SITE PLAN FOR CLEAN EXPRESS CAR WASH

10 E AUBURN ROAD ROCHESTER HILLS, MI 48309

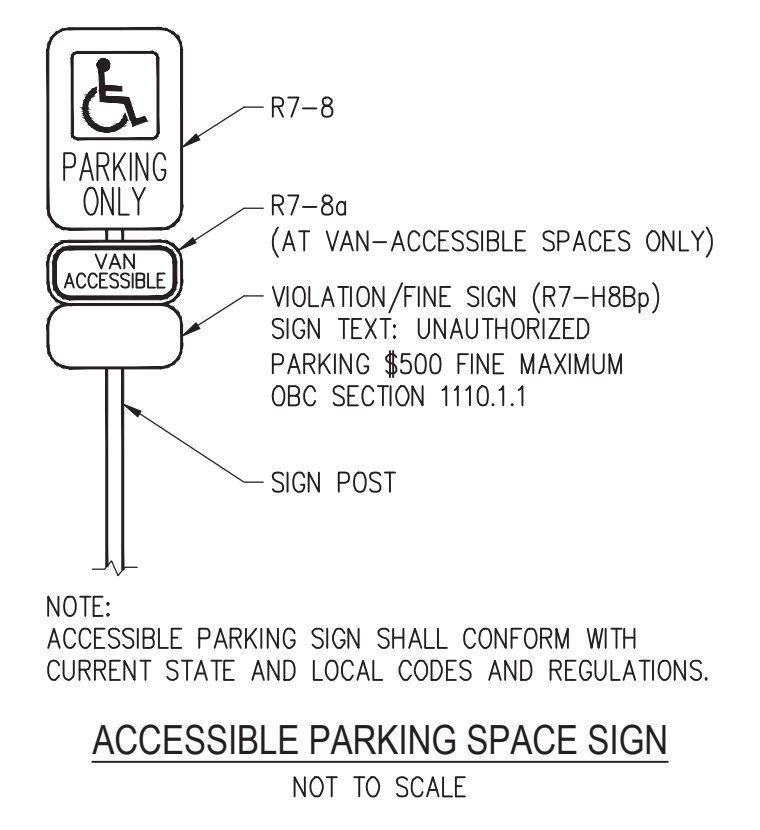
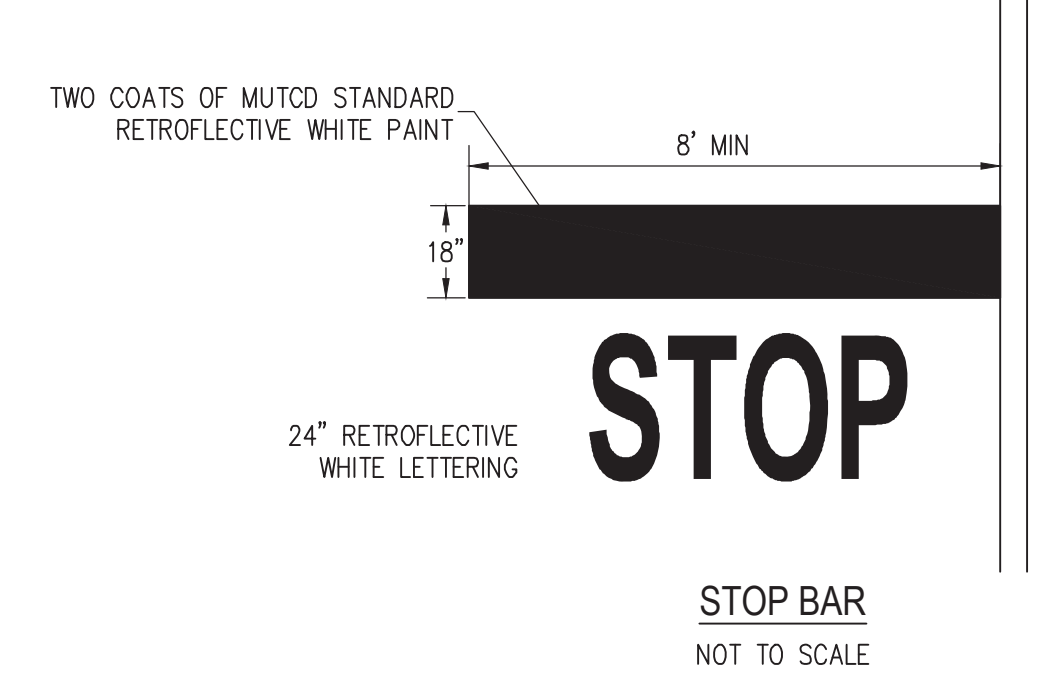
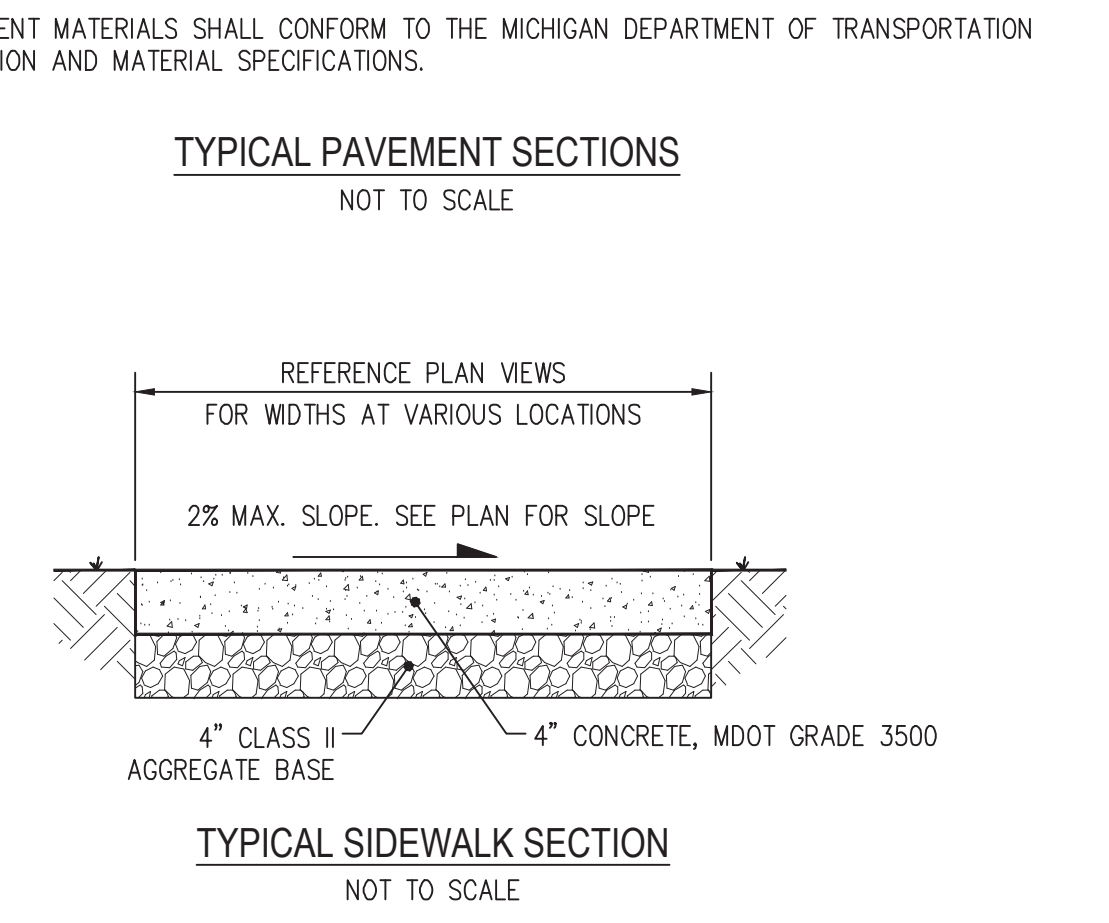
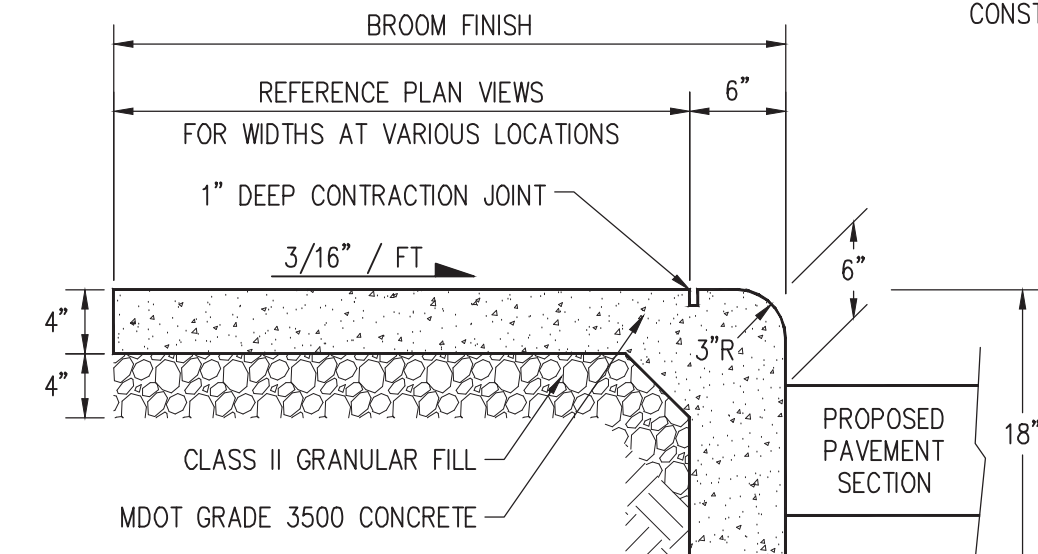
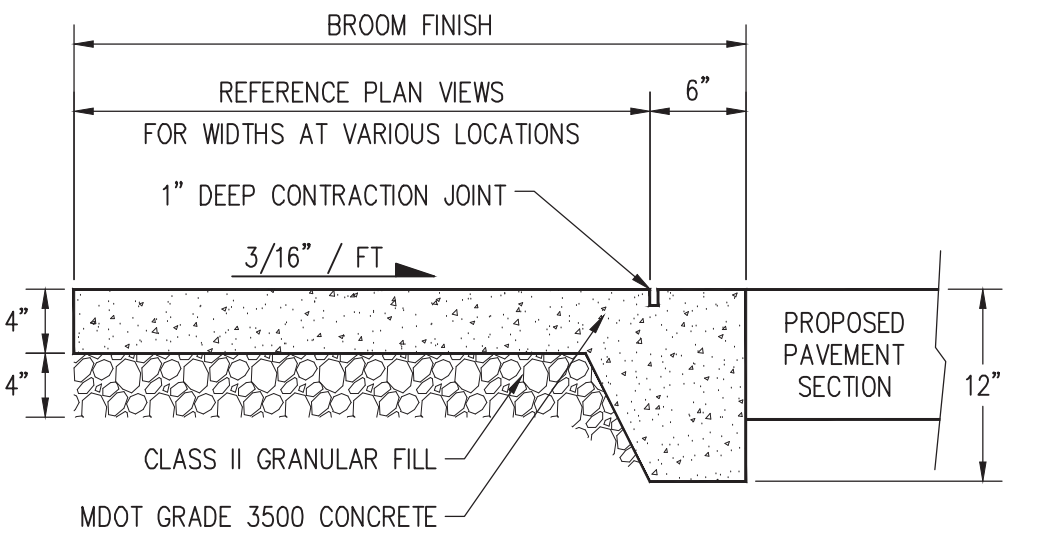
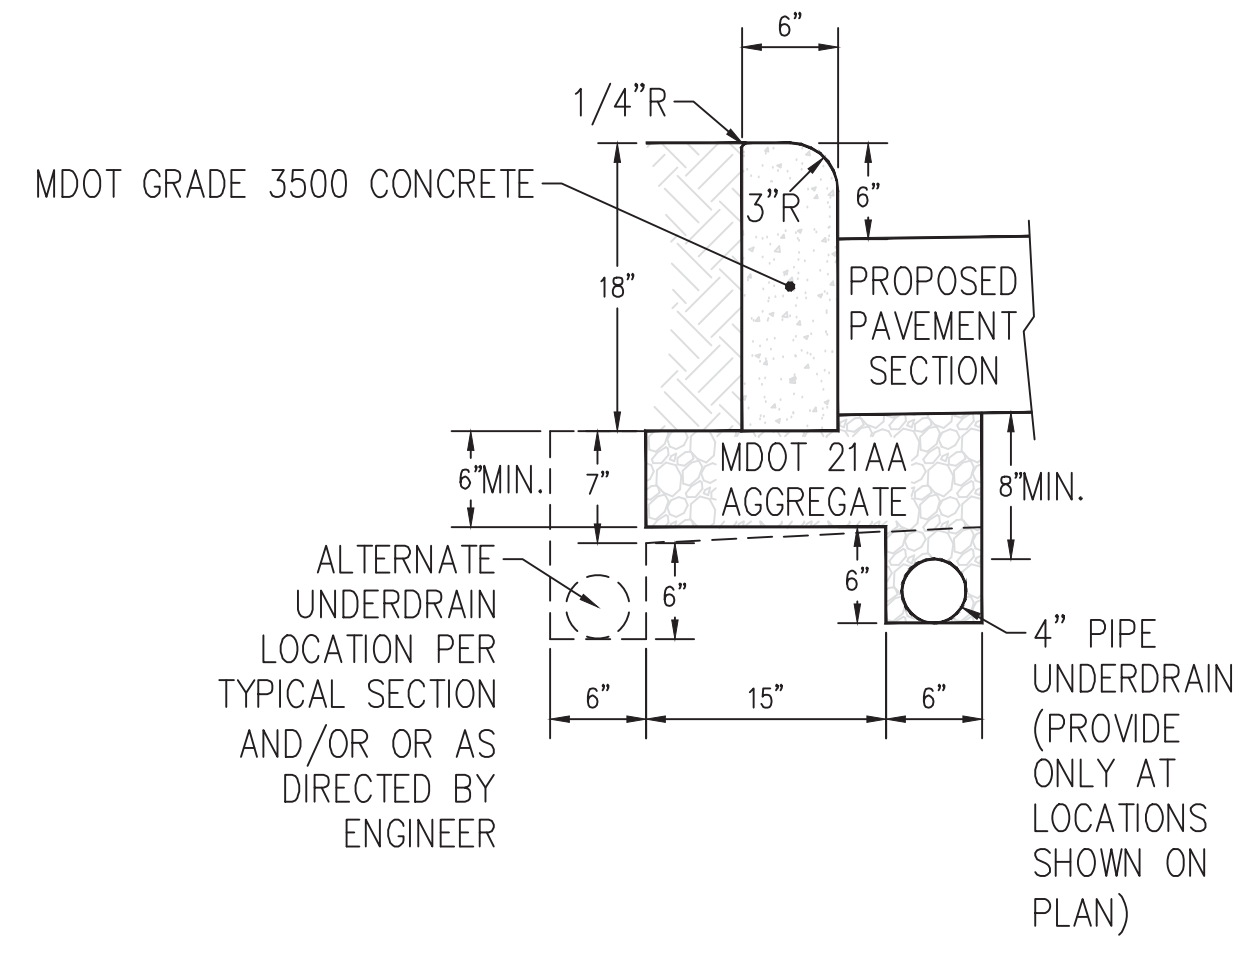
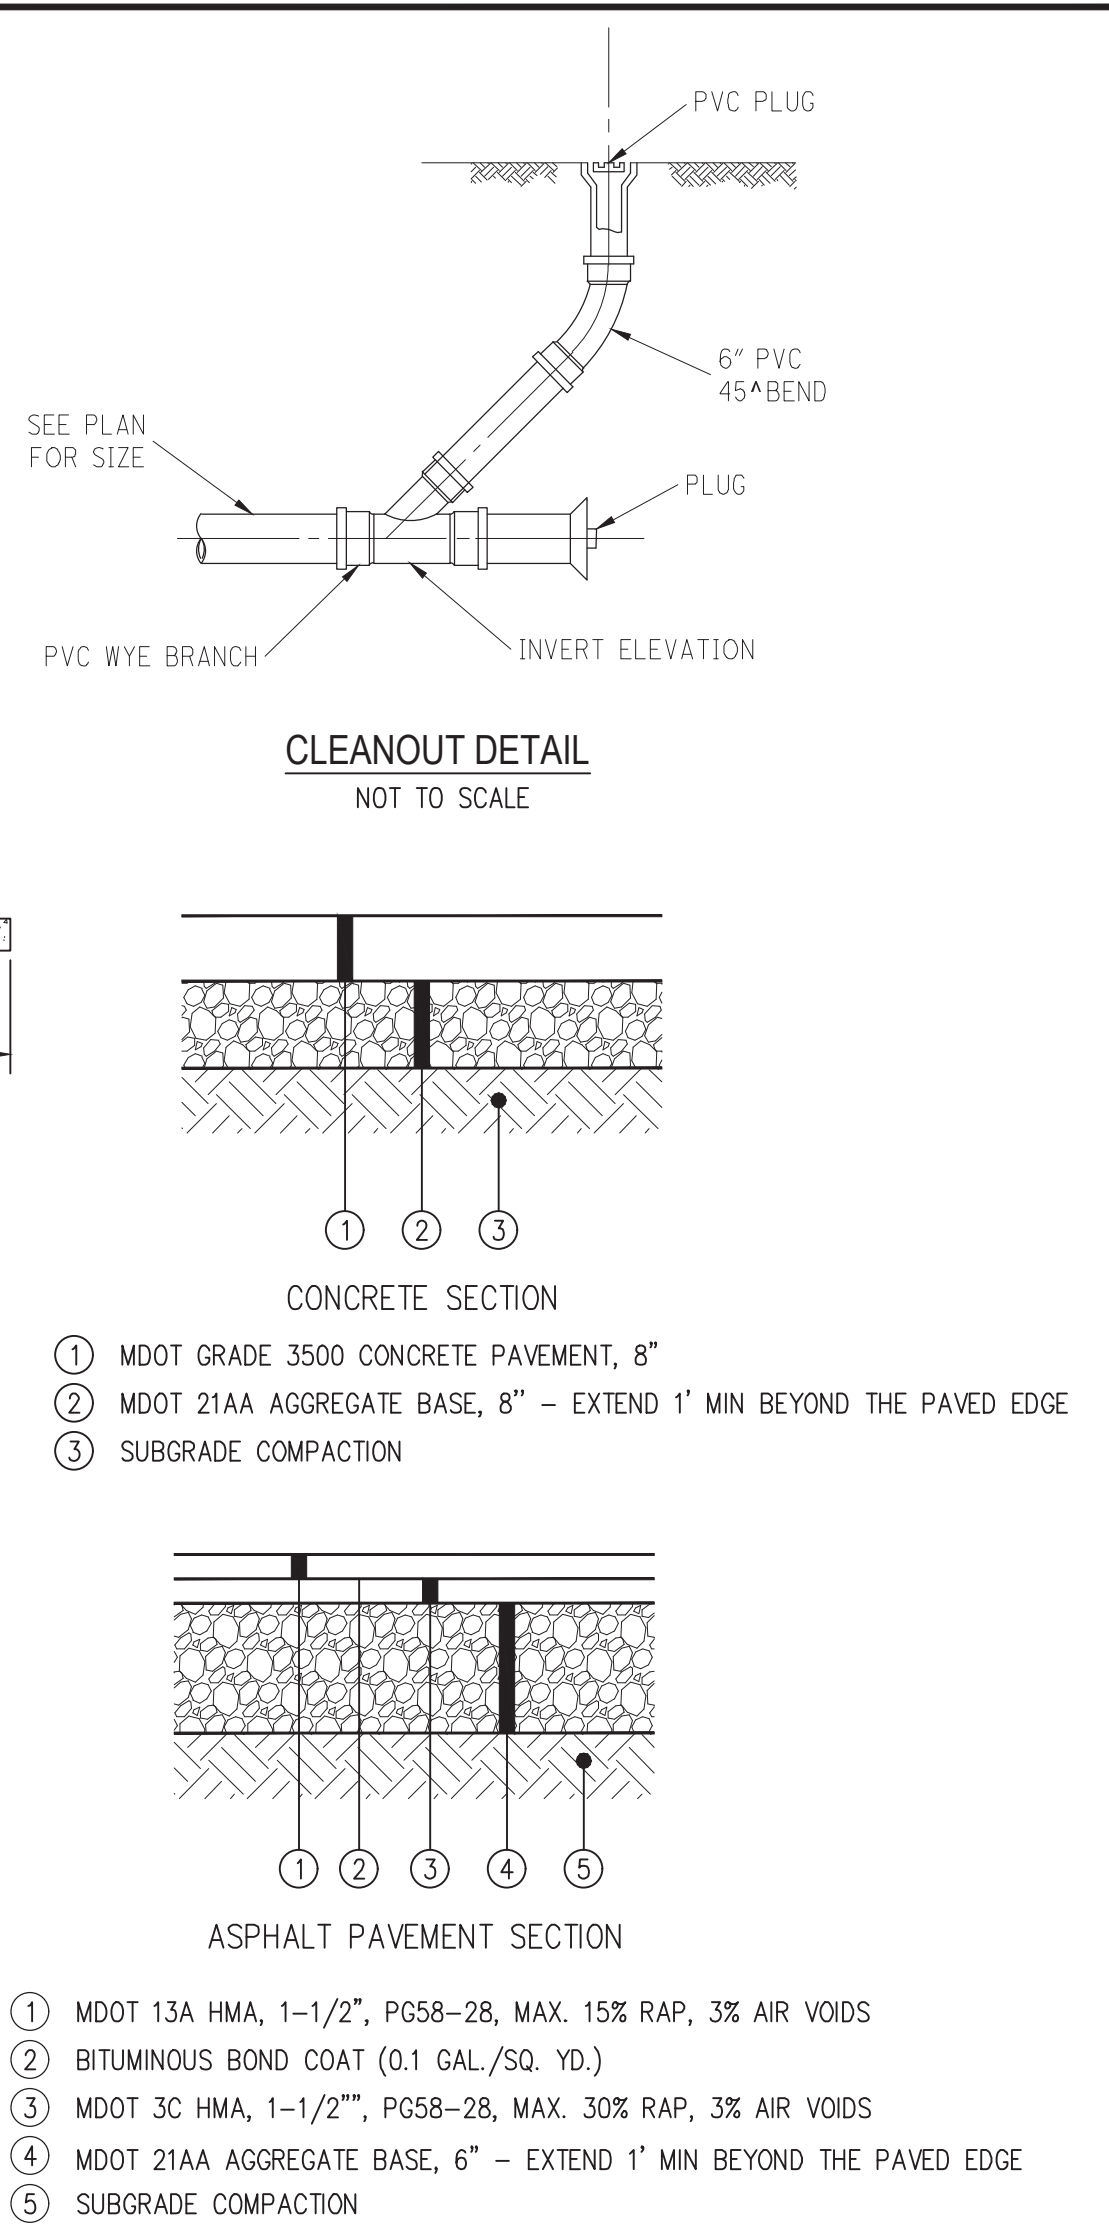
The applicant needs to submit a Land Improvement Permit (LIP) application with engineer's estimate, fee and construction plans to proceed with the construction plan review process.
